SUBJECT: Response to Inquiries regarding FA8601-26-Q-0070, F20553 Furniture Project 2025SH172

Questions & Answers:

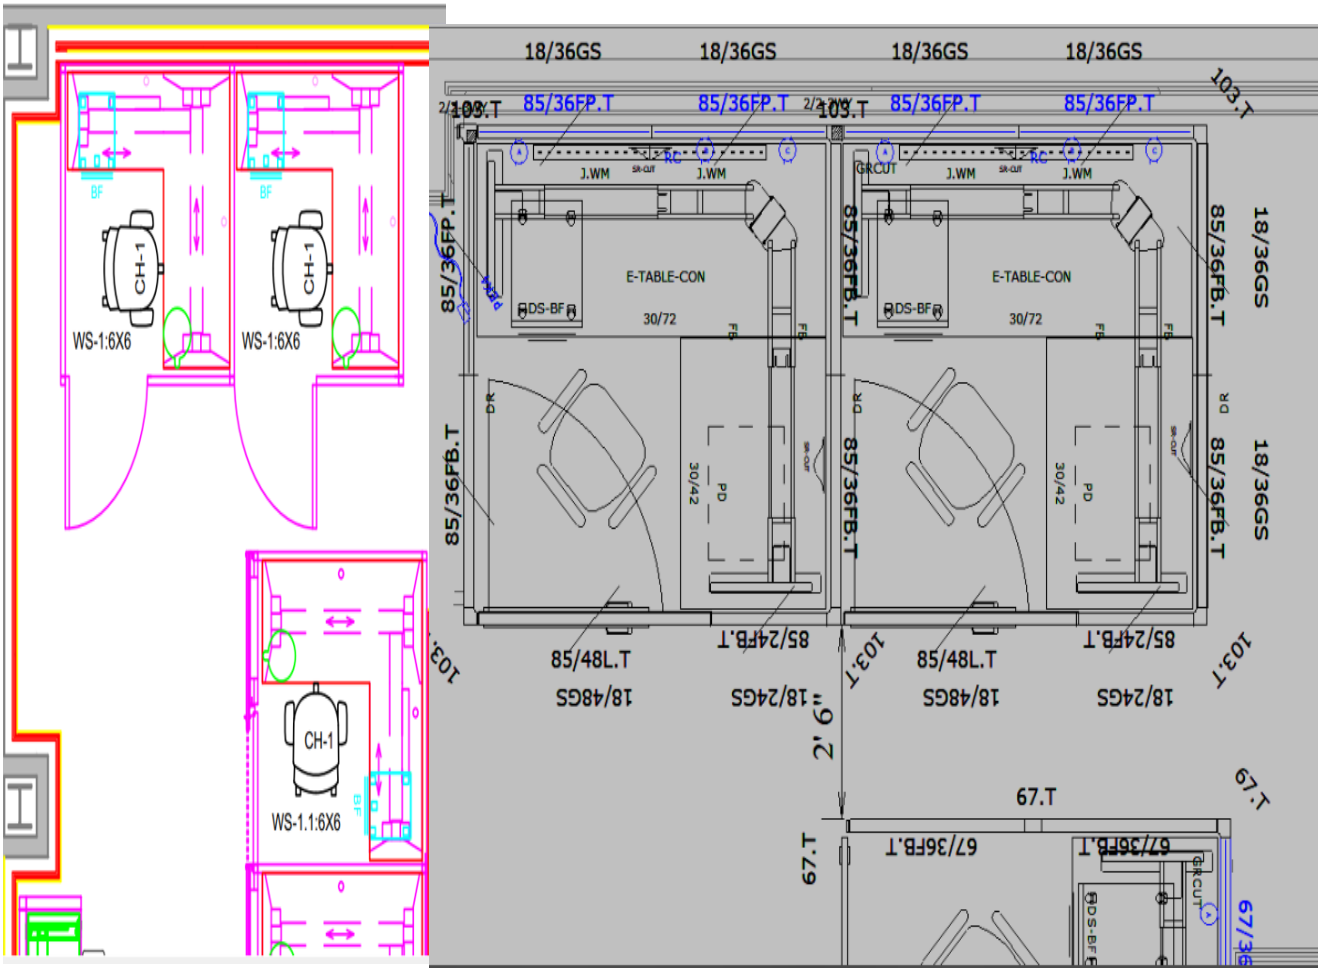
16. Due to the tight space conditions in this area, would sliding doors be acceptable instead of swing doors? Also, would 24” deep desk returns be acceptable, deeper returns would overlap with the doors**. Answer: Yes, sliding doors are acceptable. 24” deep return is acceptable since a deeper return would interfere with the door.**

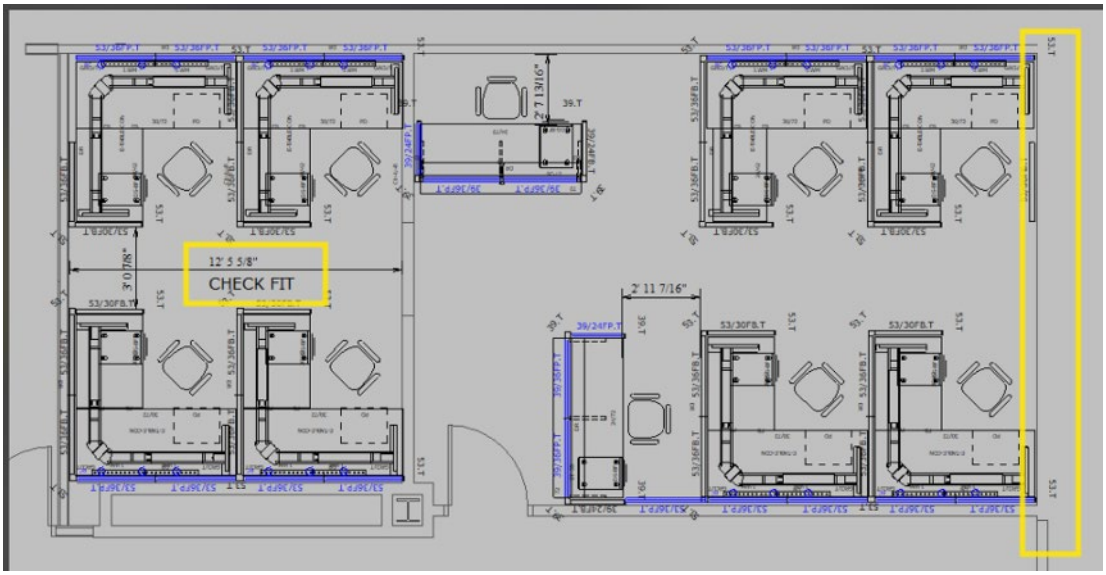
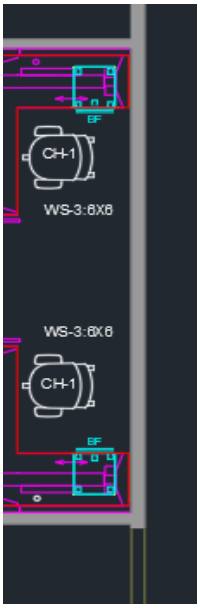
18. We’d like to confirm that the dimension shown (image below) in yellow is correct.
    Answer: The DWG dimension is 12’-6-1/8”

19. Also, could you please confirm whether the area highlighted in yellow on the right represents an existing wall?
    Answer: Yes, there is an existing wall. See image that shows the wall.
